Addendum to IFB

IFB NUMBER: IFB 24-065/MR
IFB TITLE: Jefferson County Doggett Park Midway Rehabilitation
IFB DUE BY: 11:00 am CT, Wednesday, November 20, 2024
ADDENDUM NO.: 1
ISSUED (DATE): November 14, 2024

JEFFERSON COUNTY ENGINEERING DEPARTMENT JEFFERSON COUNTY COURTHOUSE 1145 PEARL STREET, 5TH FLOOR BEAUMONT, TEXAS 77701 PHONE: (409) 835-8584 FAX: (409) 835-8718	
PROJECT: DOGETT FORD PARK MIDWAY ASPHALT REHABILITATION	
SHEET 5 OF 9	SHEET QUANTITIES 05
DRW'N. BY: G.K.	
CHK'D. BY: M.F.

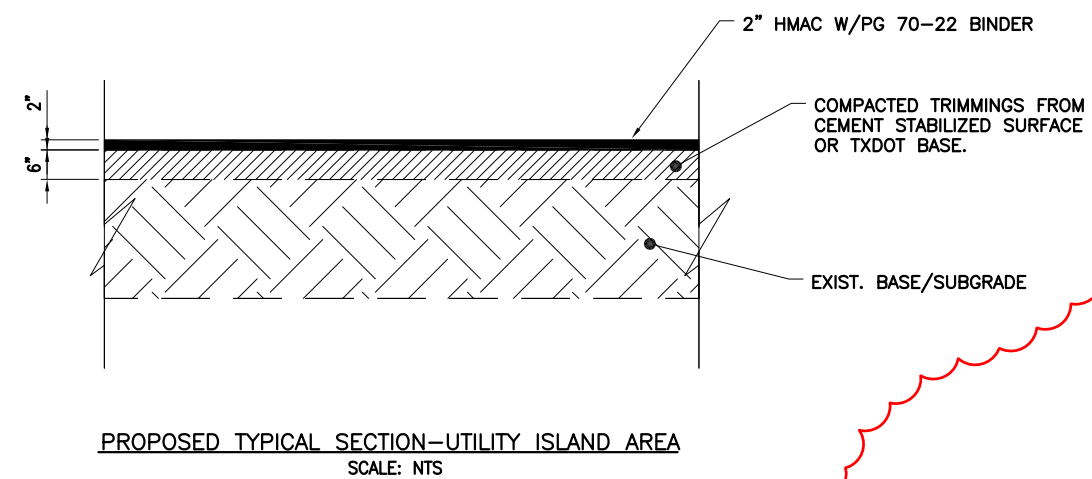
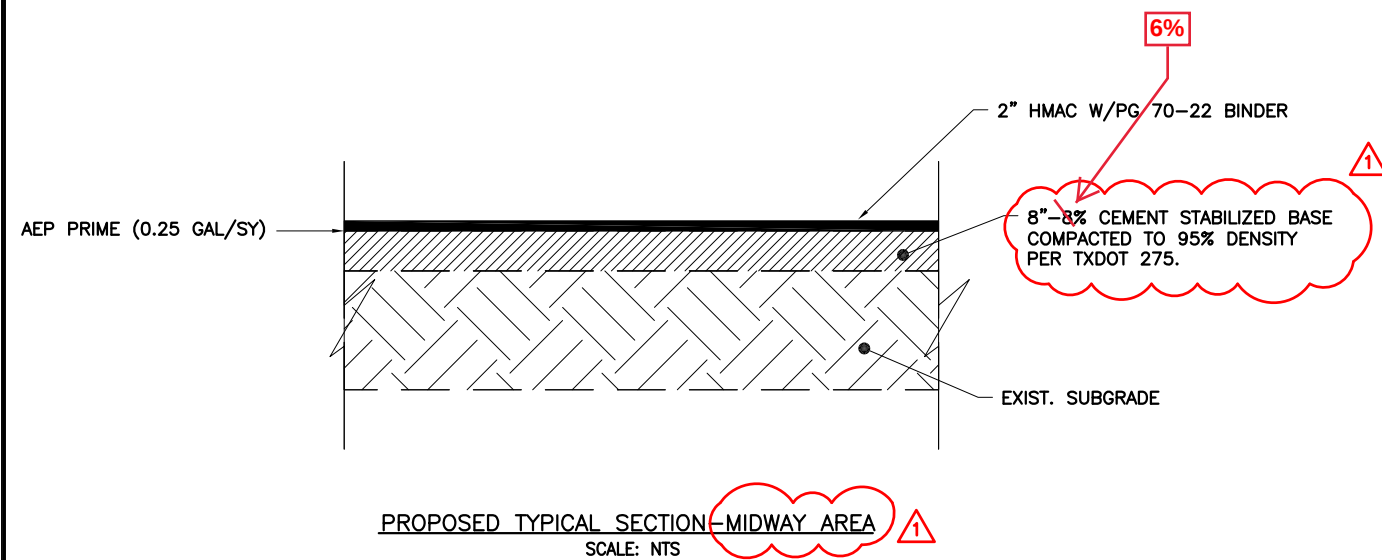
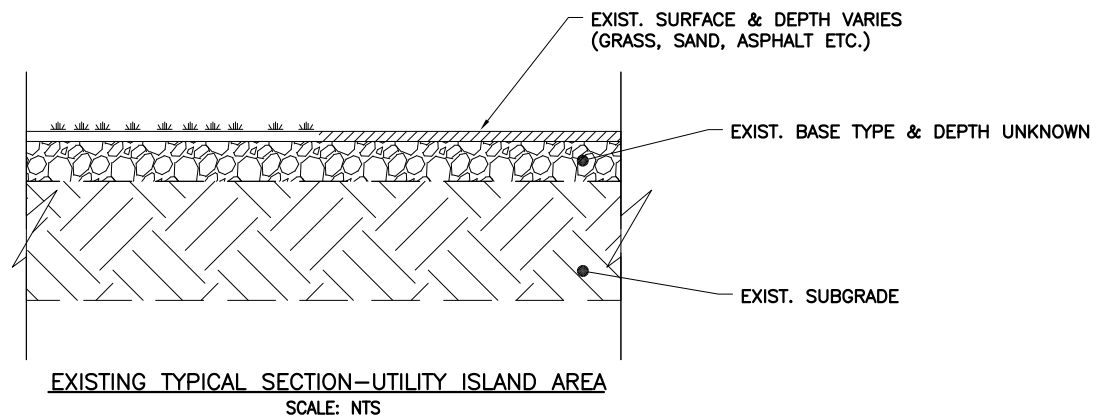
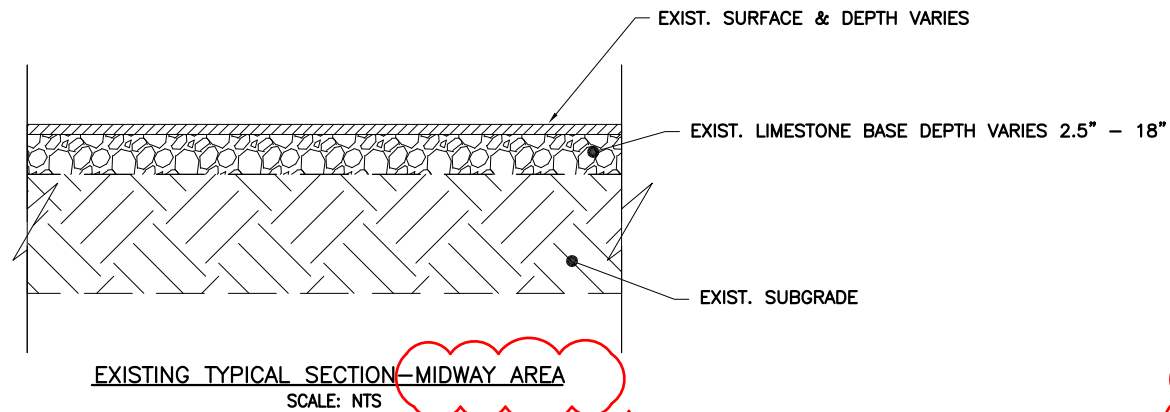
REV 1 Addendum #1 Modifications
11-13-2024

SQUARE YARDS OF SURFACE (SY) 39,900.0
EXCAVATION (INCHES) ~~2.25~~ 2.75
CEMENT LIME STABILIZATION (INCHES) 8.0
HMAC (INCHES) 2.00

Bid Item	TXDOT Item	BID ITEM DESCRIPTION	Estimated Quantities	Unit
1	500	MOBILIZATION (MAX 3%)	1	LS
2	110	EXCAVATION Excavate existing surface and base (2.25" DEPTH) Stockpile on site	3048 2494	CY
3	251	REWORKING BASE COURSE (8" 10" DEPTH)	39900	SY
4	275	CEMENT TREATED SUBGRADE (Site Mixed 8" deep) 6% (TON)	1021	SY TON
5	300	AEP PRIME (0.25 GALLONS/SY)	9975	GAL
6	340	DENSE GRADED HOT-MIX ASPHALT 2 inches thick, PG 70-22 (20% RAP Allowed)	4608	TON
7	351	FLEXIBLE PAVEMENT SUBRADE REPAIR	400	SY
8	502	BARRICATES AND TRAFFIC/PEDESTRIAN HANDLING	1	LS

JEFFERSON COUNTY ENGINEERING DEPARTMENT JEFFERSON COUNTY COURTHOUSE 1149 PEARL STREET, 5TH FLOOR BEAUMONT, TEXAS 77701 PHONE: (409) 835-8584 FAX: (409) 835-8718	
PROJECT: DOGGETT FORD PARK MIDWAY ASPHALT REHABILITATION	
SHEET 8 OF 9	SHEET DETAILS
DRW'N. BY: G.K.	08
CHK'D. BY: M.F.

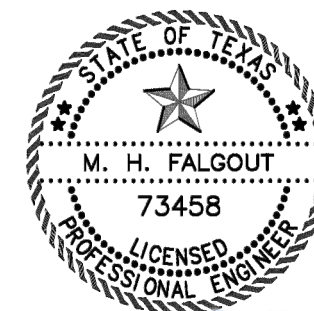
6. Question: For the utility locations requiring Hand work – would excavation of the areas of 8" with placement of Clippings in the 8" and 2" Asphalt.

9. Question: During the prebid meeting, there were comments regarding bollards and minor structures where it seemed that someone wanted organic growth items removed. There is not a typical treatment designated for these areas. Please elaborate on what type of zero scape treatment the agency is desiring because right now there is nothing specific to assign pricing to. Is there a minimum or maximum boundary for the hot mix placement and cement stabilization.

REV 1 ADDENDUM #1 MODIFICATIONS
ADDITION OF UTILITY ISLAND
DETAILS & OTHER MISC. MODS
11-13-24

Answer: See added "utility island" detail on to Project Plans Sheet 8 (Attachment D).

Answer: See added "utility island" detail on Project Plans Sheet 8 (Attachment D).

- NOTES:
- 1) SEE GEOTECHNICAL REPORTS FOR EXISTING MATERIALS INFORMATION.
 - 2) CONTRACTOR SHALL PERFORM ANY HAND WORK NECESSARY TO PROVIDE THE REQUIRED SECTIONS AROUND ALL UTILITY ISLAND AREAS, FIRE HYDRANTS, BOLLARDS, ELECTRICAL PADS, LIGHT POLE STANDS, BUILDING FOUNDATIONS, ETC.
